LINOTYPE IMPROVEMENT INFORMATION SHEET

NO. 342

MOLD TURNING GEAR COVER, A-1012 (A-1025 ASSEMBLED)

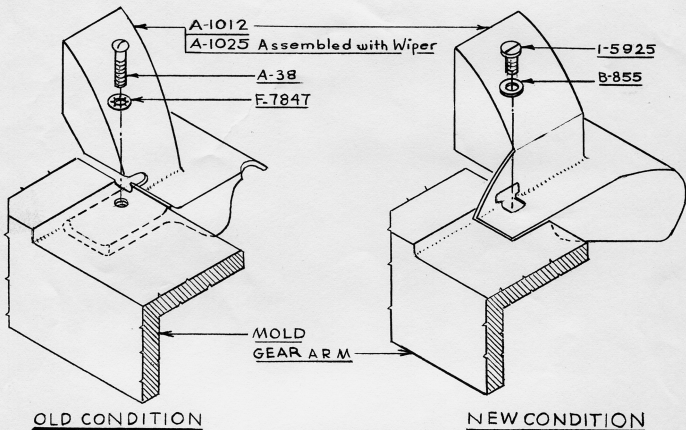
This gear cover has been redesigned to eliminate the possibility of it shifting and to permit easier application. The redesigned cover is fastened to the top of the mold gear arm instead of the underside and is held in place by a I-5925 screw and a B-855 washer.

Can be applied to outstanding Linotypes by drilling and tapping a 5/16" x 18 hole in the mold gear arm and using one I-5925 screw with a B-855 washer
